**2018 Nelson and Marlborough airspace
review
Final airspace changes**

Figure 4 – requested additional control area

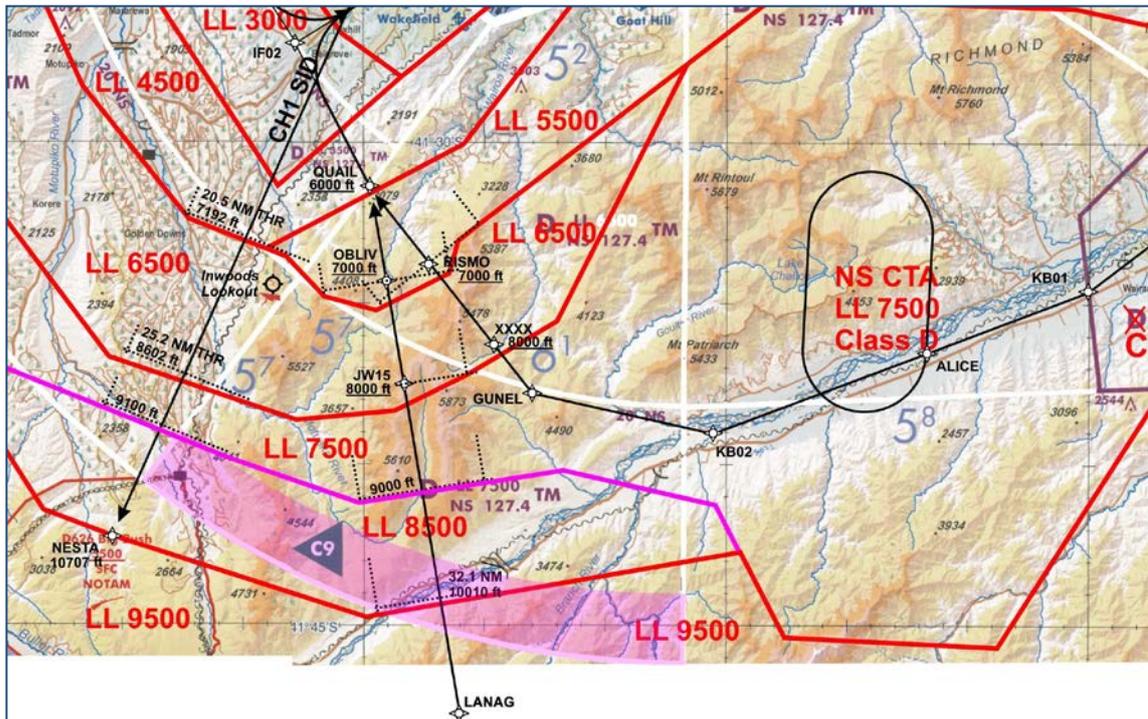
In response to gliding organisations' submissions, Airways considered a further CTA with a lower limit of 8500 ft south of Nelson in the vicinity of the Beeby Ranges. Refer to Figure 4. Airways stated that this request was not part of their submission, and that the diagram was to indicate what may be possible. However, it was not assured that appropriate containment would be provided to instrument procedures.

CAA comment: CAA has considered this proposal, and based on the information provided as well as discussions at the consultation meeting, has the following additional concerns about the airspace:

- Further complexity to the airspace south of Nelson
- The initial assessment indicates minimal buffers to descent profiles at higher altitude
- The outer boundary of the CTA with 7500 ft lower limit is at 26 NM Nelson. This is on the edge of the climb/descent gradient design parameter of 300 ft/NM.

Based on these concerns, CAA does not support the requested additional CTA at this time. Following the implementation of the airspace changes, a review will be undertaken to ensure that the changes remain fit-for-purpose. This request will form part of this review, along with the review of GAAs in the vicinity of Lake Station and Hanmer aerodromes (see below).

Figure 5 – new VRPs

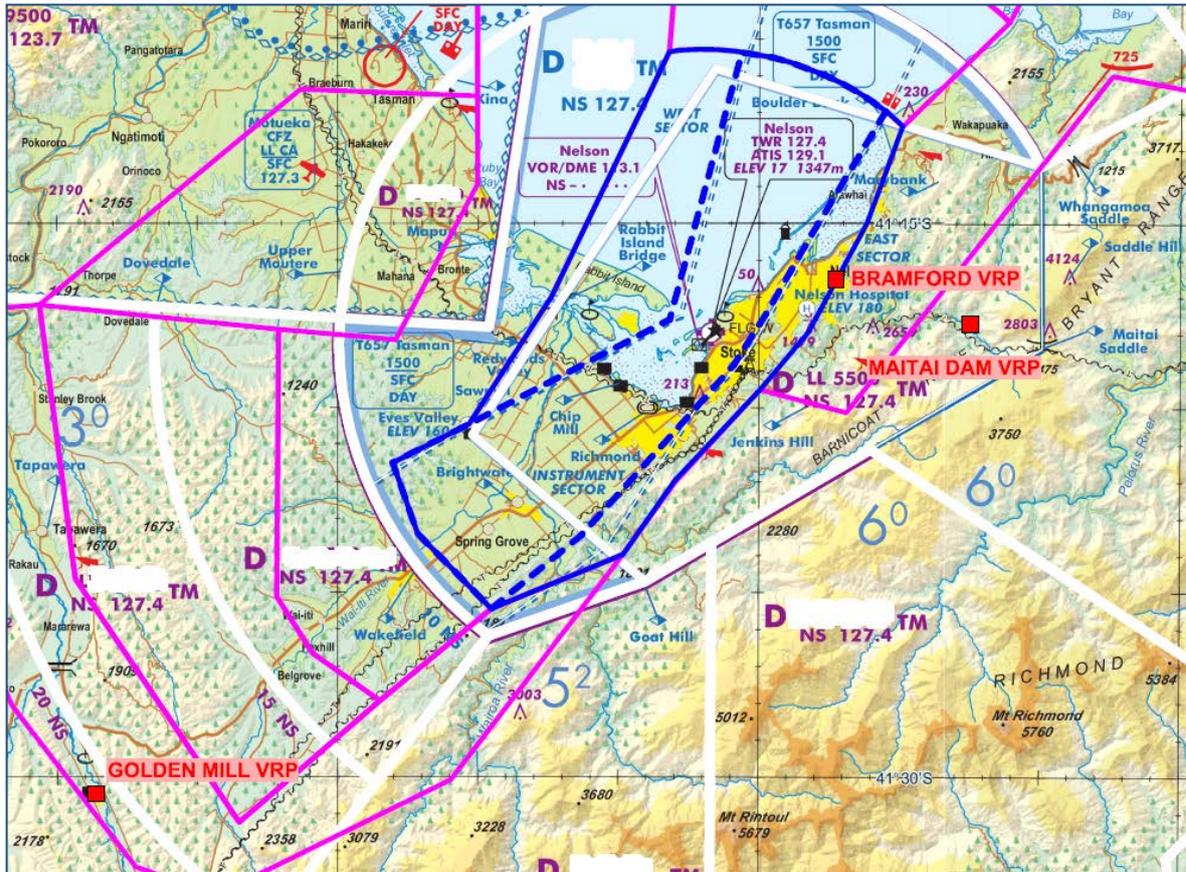
- Delete Marybank and Saddle Hill VRPs
- Change existing VRP name from *Richmond* to *Racecourse*;
- Change existing VRP name from *Boulder Bank* to *Boulder*;
- Add new VRP *Bramford* (refer Figure 5), S 41 16 26.3, E173 17 44.4 (centre of park to the east of Nelson);
- Add new VRP *Maitai Dam* (refer Figure 5) at S 41 17 38.6, E 173 22 31.3 (small lake east of Nelson);
- Add new VRP *Golden Mill* (refer Figure 5) at S 41 30 23.2, E 172 51 22.1 (building symbol shown on current VNC at approximately 20 NM SW of Nelson)

In addition to the VRP changes, Airways has also requested that a town name label is added to Richmond on the VNCs, similar to Stoke and Nelson.
